## TECHNICAL INFORMATION N°2003 - 47

### Chassis : ITC008

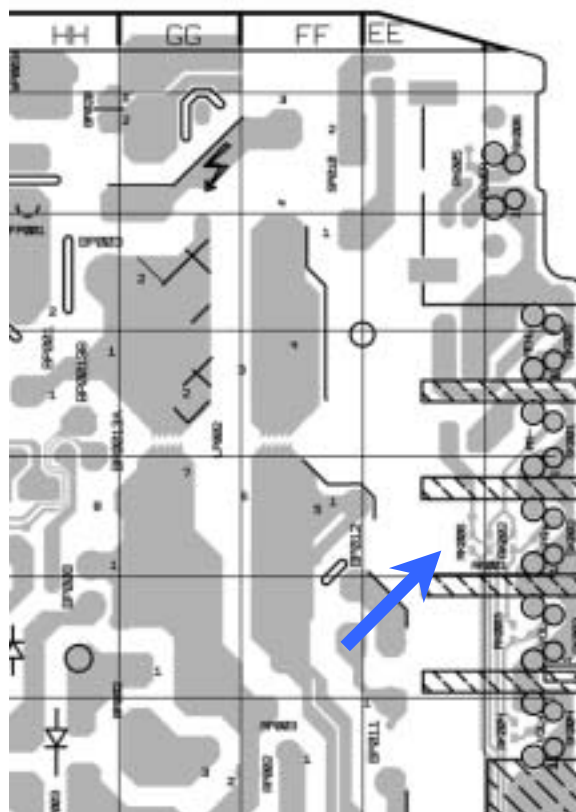
#### Symptom / Problem observed :

After 2 or 3 working hours, the set switch OFF and switch ON again without apparent reason.  
(The symptom is repeated every 45 minutes)

Remove the resistor in position RK006.
